TECHNICAL DOCUMENTATION CHANGE NOTICE

This Change Notice provides information that updates revision 002 of the KC750 Technical Manual, EK-KC750-TM. The information on pages 1 through 5 of this Change Notice was published previously as Change Notice EK-KC750-TM-CN1, March 1982.

MA-6289

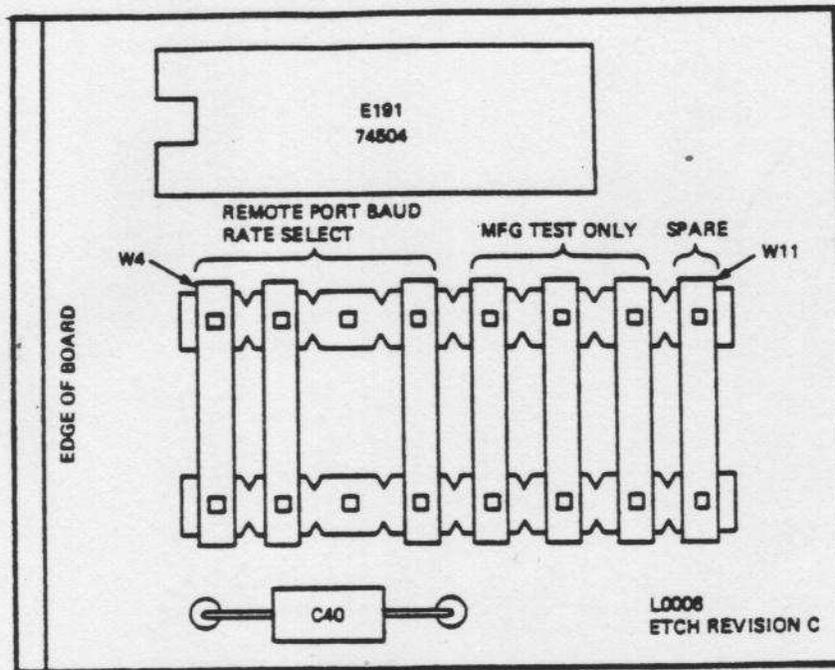
A note is added to the figure to indicate that only Revision C etch boards have the set of eight jumpers. Earlier boards have either a set of four jumpers or a four-switch pack.

ETCH REVISION C BOARDS HAVE THE EIGHT-JUMPER PACK (W4 THROUGH W11) AS ILLUSTRATED. THIS FIGURE SHOWS THE FACTORY-SET 300 BAUD CONFIGURATION.

EARLIER BOARDS HAVE EITHER A FOUR-JUMPER PACK (W4 THROUGH W7) OR A FOUR-SWITCH PACK (S1 THROUGH S4).

USE TABLE 3-2 TO CONFIGURE SWITCHES, TABLE 3-3 TO CONFIGURE JUMPERS.

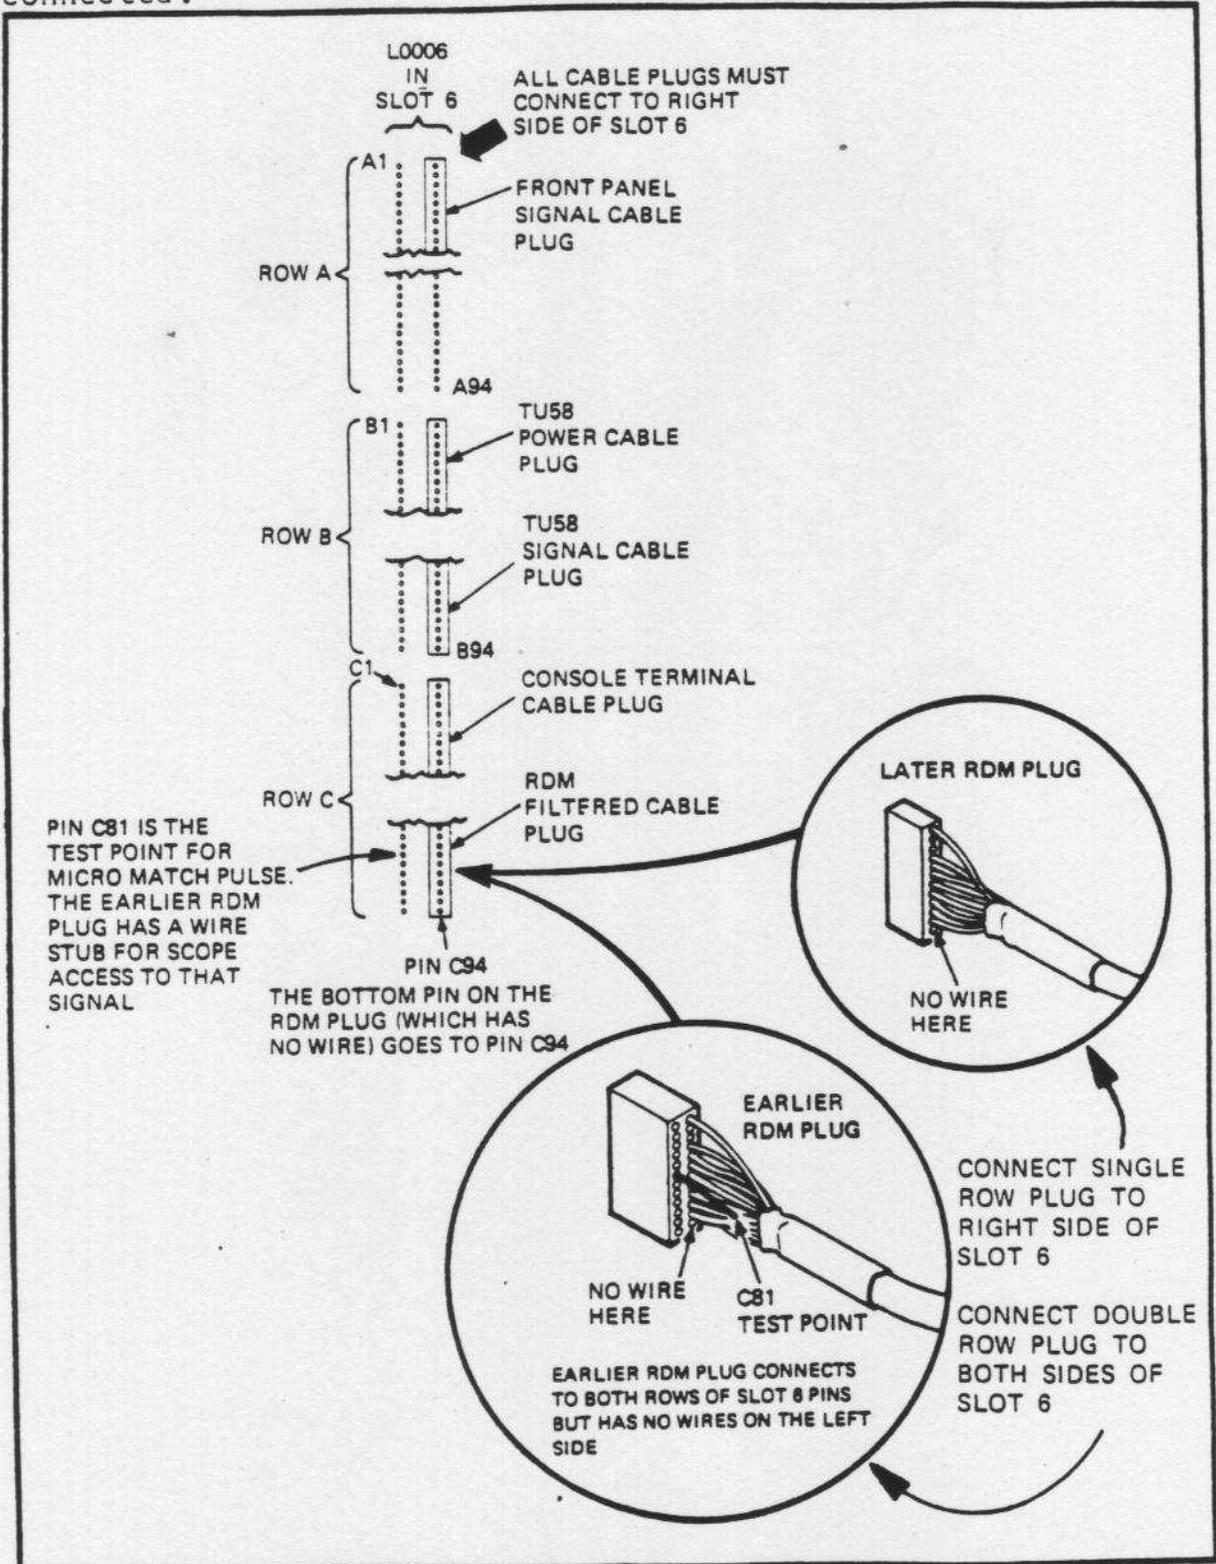
The figure is changed to show that the TU58 Power Cable plug must be connected to the pins on the right side of slot 6. Other changes show the two types of RDM plugs and how they are connected.

Figure 4-3 Remote Secure VAX Console State With Local Echo

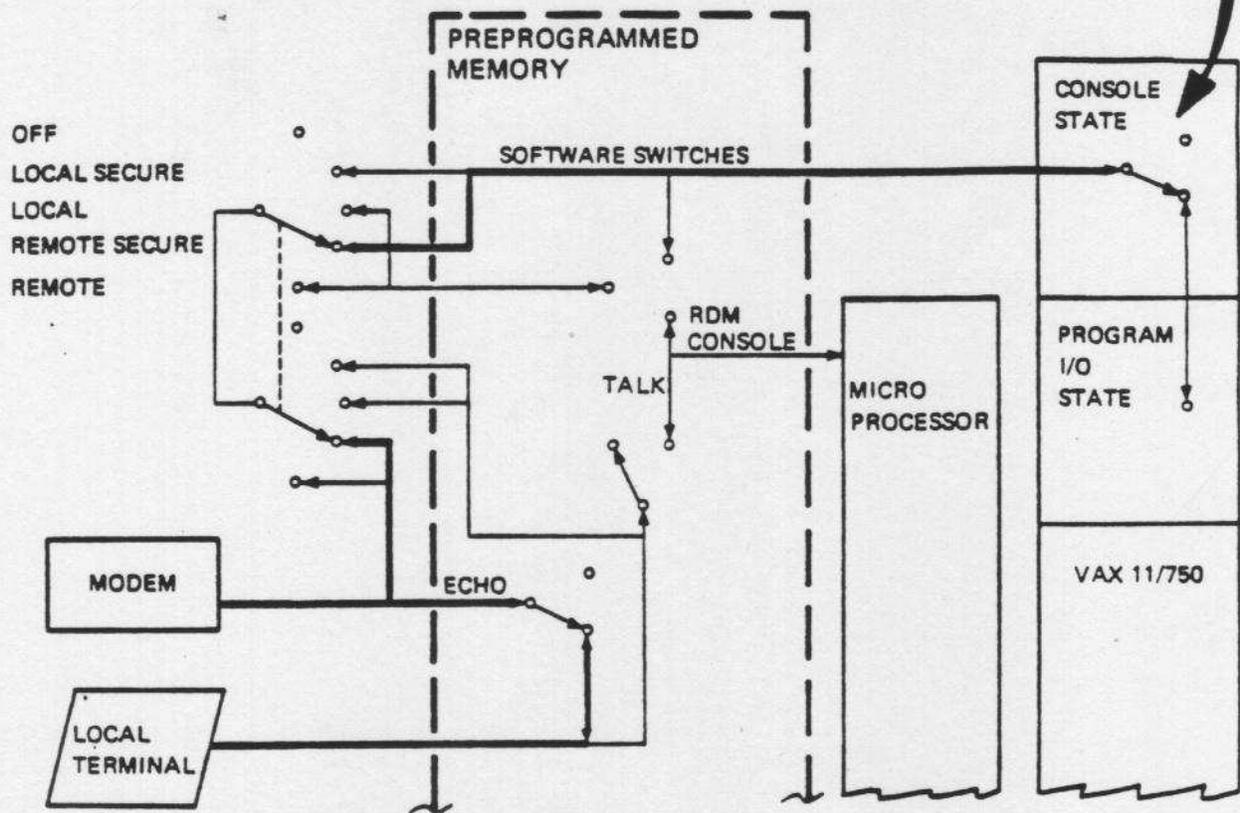
The figure is changed to show Program I/O State instead of Console State. Console State cannot be entered when the keyswitch is in the Remote Secure position.

The corrected figure title is:

"Remote Secure Program I/O State With Local Echo".

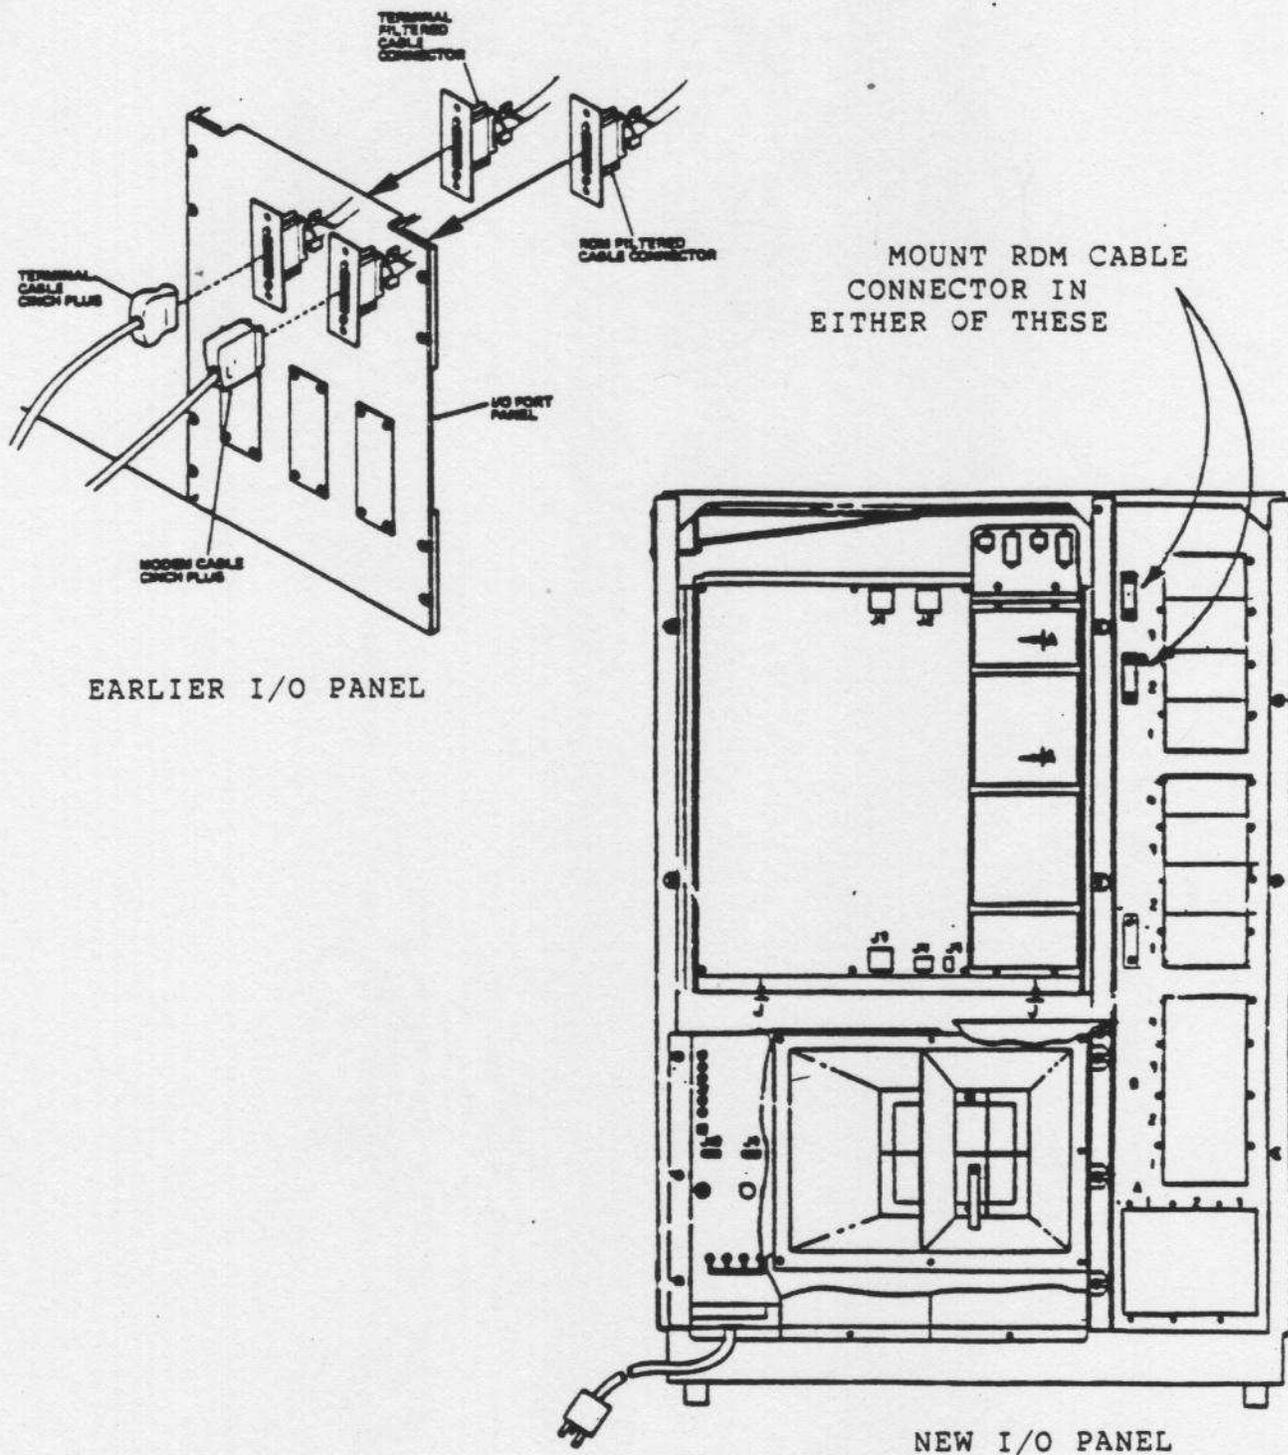
Figure 3-7 on page 3-10 shows the earlier I/O panel. The revised Figure 3-7 below now shows the new FCC-compliant I/O panel also.

Remove the blank plate, pass the cable connector through the port, and secure it using the same screws.
